Access Compliance Report

Public Rights-of-Way

Intersection ID: 48769	Main Street: KNOTHOLE_LN	Cross Street: SONOMA_VALLEY_DR	Location: SE
ADA ID: 6BC3AF09EAB3	Ramp Type: PerpDiag	Initial Pass/Fail: Fail	Overall Compliance: No
Severity Score: 8.75			
Codes/Mitigation Info/Possible Solution		Field Measurements/Component Compliance

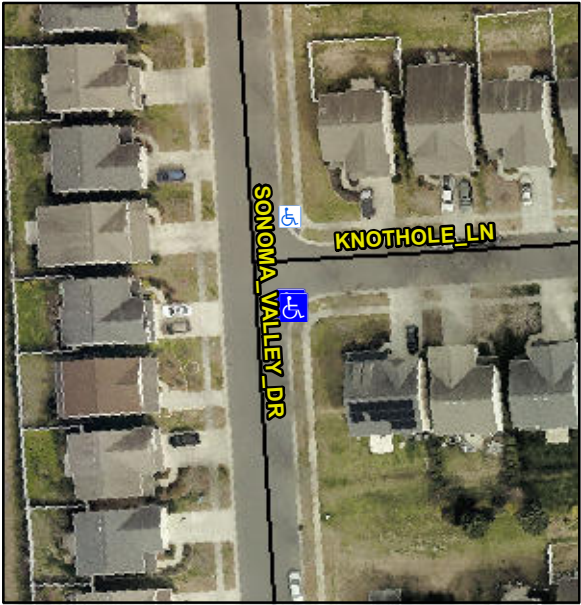
Possible Solutions:	Compliance	Description	Data	Compliance	Description	Data
	Remove & Replace Curb Ramp With Two New Directional Ramps or Equivalent.	N/A	Ramp Length (in)	72.0	Yes	Ramp Slope (%)	6.0
		No	Ramp Width (in)	47.0	Yes	Ramp XSlope (%)	1.3
		N/A	Flare Type LT	N/A	N/A	Flare Type RT	N/A
		N/A	Flare Slope LT (%)	N/A	N/A	Flare Slope RT (%)	N/A
		N/A	Flare Traversable LT?	N/A	N/A	Flare Traversable RT?	N/A
		N/A	Landing Length (in)	N/A	N/A	DWS Provided?	N/A
		N/A	Landing Width (in)	N/A	N/A	DWS Contrast?	N/A
		N/A	Landing Slope (%)	N/A	N/A	DWS Length (in)	N/A
		N/A	Landing X Slope (%)	N/A	N/A	DWS Full Width?	N/A
		N/A	Landing Curb? (Y/N)	N/A	N/A	DWS Offset (in)	N/A
		N/A	Shared Landing?	N/A			
		N/A	Gutter Ponding?	N/A	N/A	Gutter Slope (%)	N/A
		N/A	Gutter Lip Ht (in)	N/A	N/A	Gutter X Slope (%)	N/A
		N/A	Painted X Walk1?	No	N/A	Painted X Walk2?	No
			X Walk 1 Direction	To N		X Walk 2 Direction	To W
		N/A	X Walk 1 Width (in)	N/A	N/A	X Walk 2 Width (in)	N/A

X Walk 1 Slope (%)	2.2		X Walk 2 Slope (%)	1.3
			X Walk 1 X Slope (%)	0.5		X Walk 2 X Slope (%)	0.5
		N/A	Ramp inside XWalk1?	N/A	N/A	Ramp inside XWalk2?	N/A
<p>Surveyor Notes:</p> <p>N/A</p> <p>PROW/ADA:</p> <p>Not Found, R304.5.1</p>			Road Slope (%)	1.0	N/A	Clear Space?	N/A
			Road X Slope (%)	0.9	N/A	Clear Space to XWalk (in)	N/A
<p>Total Cost:</p> <p>\$ 3200.00</p>		N/A	Any Obstructions?	N/A	N/A	Storm Grate/Utility Hazard?	N/A
			Obstruction Type			Storm Grate/Utility Type	
				N/A			N/A
				Yes		Surface Condition? (G/P)	Good
